GROUND GAS RESISTANT MEMBRANE INSPECTION RECORD

Project:	VICTORIA AVENUE, BLACKLEY
Project No:	3951
Plot No. Inspected:	11
Date of Inspection:	12/12/2023
Inspected By:	PSP
Inspection Method:	VISUAL AND PICK TESTING

Figure 5 – Hand Welded Seams

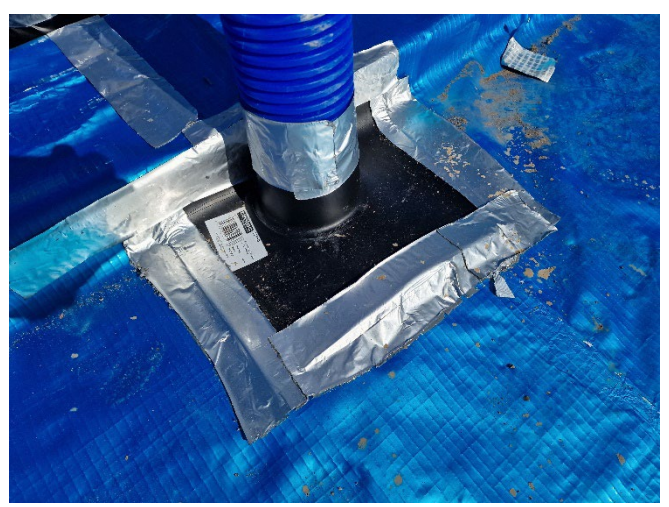
INSPECTED ITEM	YES/NO	COMMENTS	PHOTOGRAPHED YES / NO
Identification Identify that the correct membrane has been used, including sealing / jointing tape and pre-formed components e.g. tophats, corners.	Y	Visqueen 'Gas Barrier' membrane 'Pro Detailing Strip' Pre-formed top hats Double sided jointing tape	Y
General Condition Inspect the general condition of the membrane for rips, tears and punctures.	Y	Membrane in good condition. No holes.	Y
Jointing Check that all jointing has been carried out to the manufacturer's specification.	Y	Hand welded jointing. gaps found in jointing at corners and edge of detailing strip. Correctly patched and witnessed during inspection.	Y
Installation Check that the membrane has been installed correctly across cavities, including correct jointing in these areas.	Y	Sufficient lap covering cavity. Corners installed correctly.	Y
Top Hat Installation Check that top hats have been correctly installed around service entries, including jubilee clip around pipe and correct lapping and jointing to membrane at base.	Y	Additional tape added to perimeter of top hats to reinforce the stability. Completed under supervision.	Y

Figure 4 – Holes and gaps in jointing correctly patched.

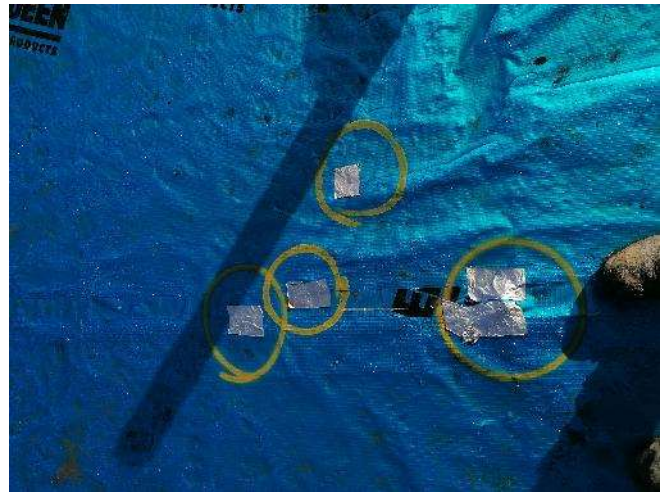
INSPECTED ITEM	YES/NO	COMMENTS	PHOTOGRAPHED YES / NO
Identification Identify that the correct membrane has been used, including sealing / jointing tape and pre-formed components e.g. tophats, corners.	Y	Visqueen 'Gas Barrier' membrane 'Pro Detailing Strip' Pre-formed top hats Double sided jointing tape	Y
General Condition Inspect the general condition of the membrane for rips, tears and punctures.	Y	Membrane in good condition. No holes.	Y
Jointing Check that all jointing has been carried out to the manufacturer's specification.	Y	Hand welded jointing. Three gaps found in jointing on previous visit. Correctly patched on return visit.	Y
Installation Check that the membrane has been installed correctly across cavities, including correct jointing in these areas.	Y	Sufficient lap covering cavity. Corners installed correctly.	Y
Top Hat Installation Check that top hats have been correctly installed around service entries, including jubilee clip around pipe and correct lapping and jointing to membrane at base.	Y	Gaps in the bases of all 6 top hats on previous visit. Correctly patched on return visit.	Y

Figure 4 – Sufficient cavity cover.

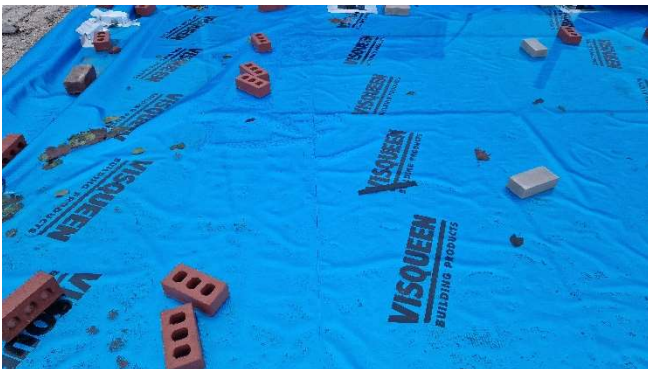
INSPECTED ITEM	YES/NO	COMMENTS	PHOTOGRAPHED YES / NO
Identification Identify that the correct membrane has been used, including sealing / jointing tape and pre-formed components e.g. tophats, corners.	Y	Visqueen 'Gas Barrier' membrane 'Pro Detailing Strip' Pre-formed top hats Double sided jointing tape	Y
General Condition Inspect the general condition of the membrane for rips, tears and punctures.	Y	Membrane recently installed in good condition. No holes, rips or tears. Installers on site during inspections.	Y
Jointing Check that all jointing has been carried out to the manufacturer's specification.	Y	Hand welded jointing. gaps found limited to outer skin of brickwork i.e. limited overlap, more membrane added and secured with detailing strip. Correct and witnessed during inspection.	Y
Installation Check that the membrane has been installed correctly across cavities, including correct jointing in these areas.	Y	Sufficient lap covering cavity for main seams. Corners installed correctly.	Y
